Transport Statement

**Proposed Residential Development
Land East of Leicester Road
Earl Shilton**

Report Reference: 923-TS-01-0

Designer's Response
MAC report ref 923-TN-01-0

Proposed Access Strategy, Without Approved Sites to the West
MAC drawing number 923-TA11A

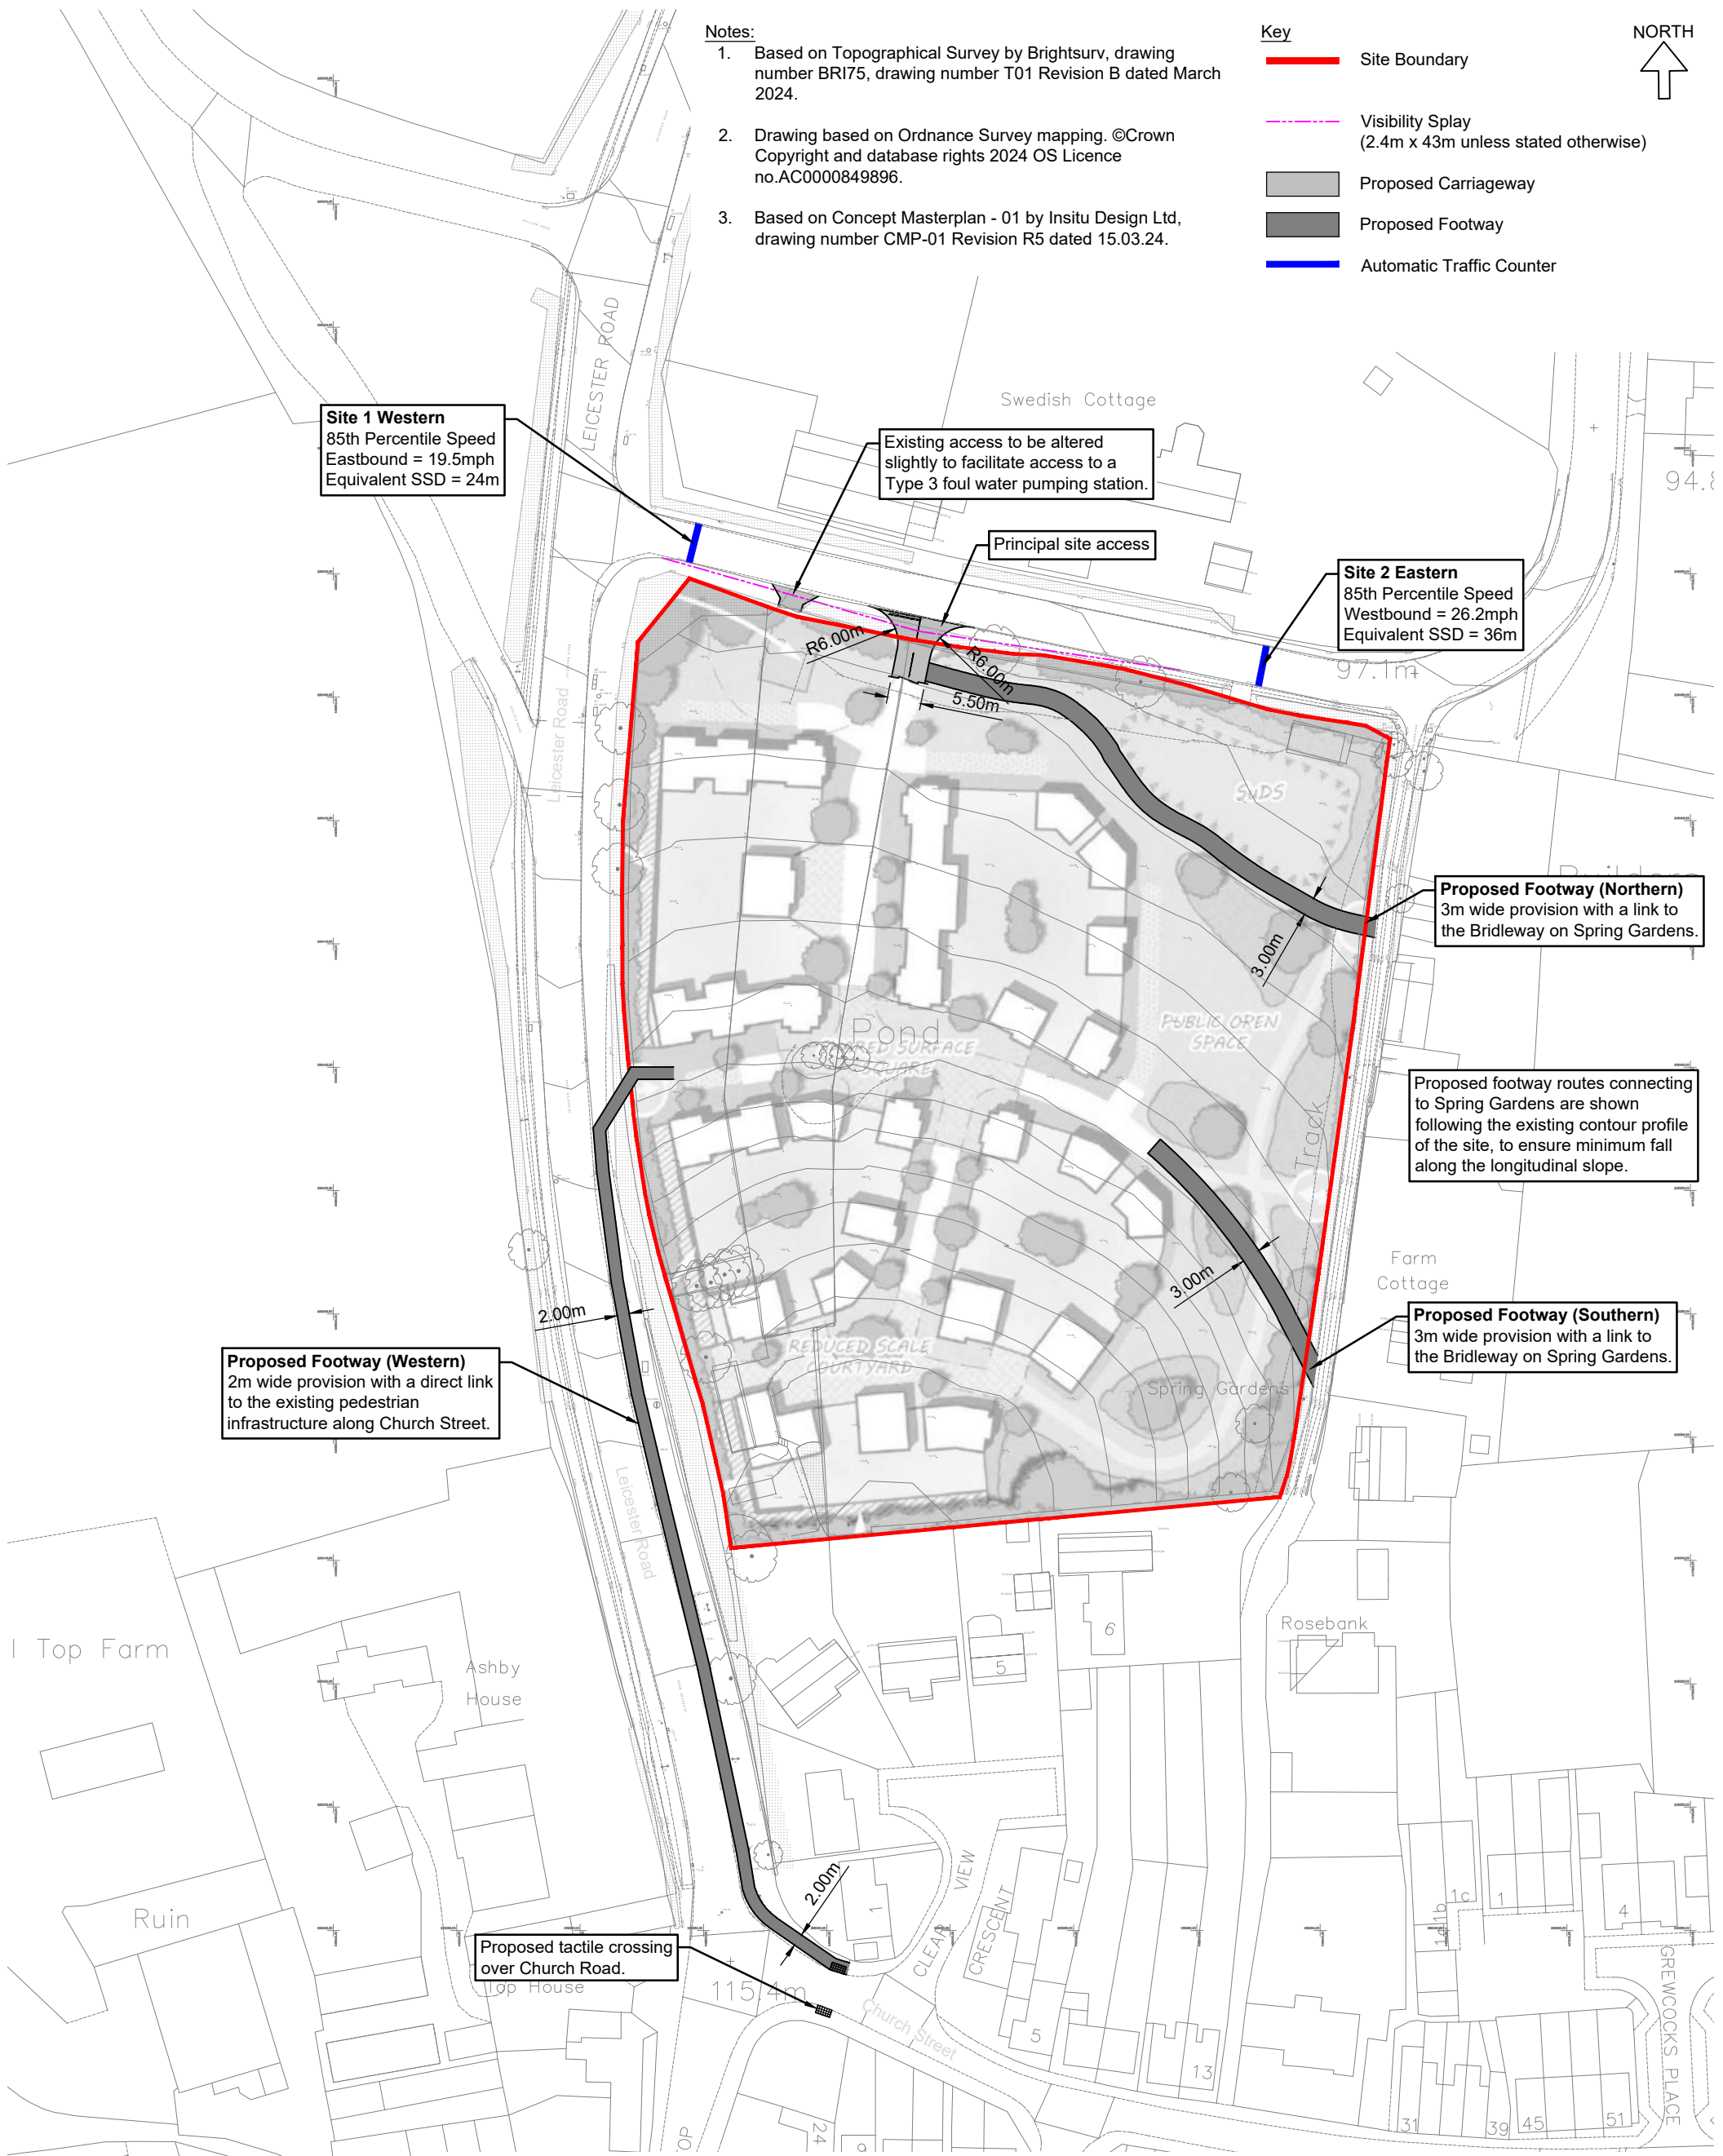
- 3.3 Pedestrians such as those with mobility issues, and unaccompanied children may find it difficult to cross Leicester Road in one stage particularly during busy periods. This may result in them waiting within the narrow central hatching strip or alternatively attempt to cross following an extended wait when the conditions to do so safely have not been met. This may increase the risk of a pedestrian being hit by a passing vehicle.

It is recommended that a two-stage crossing option is provided.

The existing Leicester Road carriageway is approximately 7.2m wide, therefore, without proposed widening, it is not wide enough to accommodate a central refuge island whilst ensuring the lane widths remain suitable for larger vehicles. Within the supporting Transport Assessment, the maximum number of pedestrian movements being generated by the development during a worst-case peak hour is 2. The level of pedestrian activity is not considered large enough to warrant localised road widening of Leicester Road in addition to the provision of a refuge island.

As a result of the above, if the approved developments to the west do not come forward, the site proposal will simply extend the proposed footway further south on the development side of the carriageway, until it connects to the footway on the northern side of Church Street. From here, pedestrians will be able to cross the Church Street which is within the 30mph zone.

Traffic Flow Diagram 8 which was produced for the 'Gladman Developments' planning application 21/00135/OUT, illustrates the forecasted flow along Church Street during the peak hour for the future 2036 scenario to be 288 two-way vehicle movements. This equates to approximately 1 vehicle every 12.5 seconds. Based on this, we believe there will be a sufficient gap between vehicles to allow pedestrians to cross Church Street safely in one stage, without the need for any central refuge island. See MAC drawing 923-TA11AB included in **Appendix D**, for further details.
